Access Compliance Report

Public Rights-of-Way

(Curb Ramps)

Intersection ID: 44118	Main Street: CORAM_PL	Cross Street: RIDING_HILL_AV	Location:	N
ADA ID: 8C54F24E99FB	Ramp Type: PerpDiag	Initial Pass/Fail: Fail	Overall Compliance: No	Severity Score: 42.5
Codes/Mitigation Info/Possible Solution		Field Measurements/Component Compliance

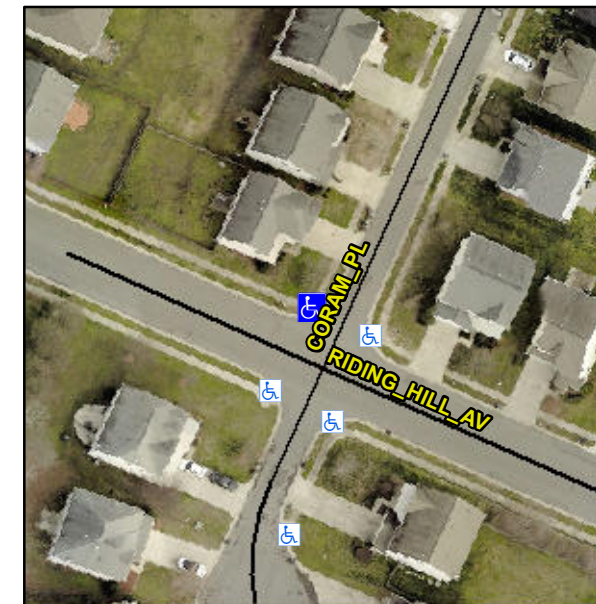
Not Found, R304.5.1, R304.5.3

Compliance	Description	Data	Compliance	Description	Data
N/A	Ramp Length (in)	48.0	Yes	Ramp Slope (%)	6.4
No	Ramp Width (in)	34.0	No	Ramp XSlope (%)	8.2
N/A	Flare Type LT	N/A	N/A	Flare Type RT	N/A
N/A	Flare Slope LT (%)	N/A	N/A	Flare Slope RT (%)	N/A
N/A	Flare Traversable LT?	N/A	N/A	Flare Traversable RT?	N/A
N/A	Landing Length (in)	N/A	N/A	DWS Provided?	N/A
N/A	Landing Width (in)	N/A	N/A	DWS Contrast?	N/A
N/A	Landing Slope (%)	N/A	N/A	DWS Length (in)	N/A
N/A	Landing X Slope (%)	N/A	N/A	DWS Full Width?	N/A
N/A	Landing Curb? (Y/N)	N/A	N/A	DWS Offset (in)	N/A
N/A	Shared Landing?	N/A			
N/A	Gutter Ponding?	N/A	N/A	Gutter Slope (%)	N/A
N/A	Gutter Lip Ht (in)	N/A	N/A	Gutter X Slope (%)	N/A
N/A	Painted X Walk1?	No	N/A	Painted X Walk2?	No
	X Walk 1 Direction	To SW		X Walk 2 Direction	To SE
N/A	X Walk 1 Width (in)	N/A	N/A	X Walk 2 Width (in)	N/A
	X Walk 1 Slope (%)	5.7		X Walk 2 Slope (%)	0.9
	X Walk 1 X Slope (%)	6.6		X Walk 2 X Slope (%)	5.3

Remove & Replace Curb Ramp With Two New Directional Ramps or Equivalent.
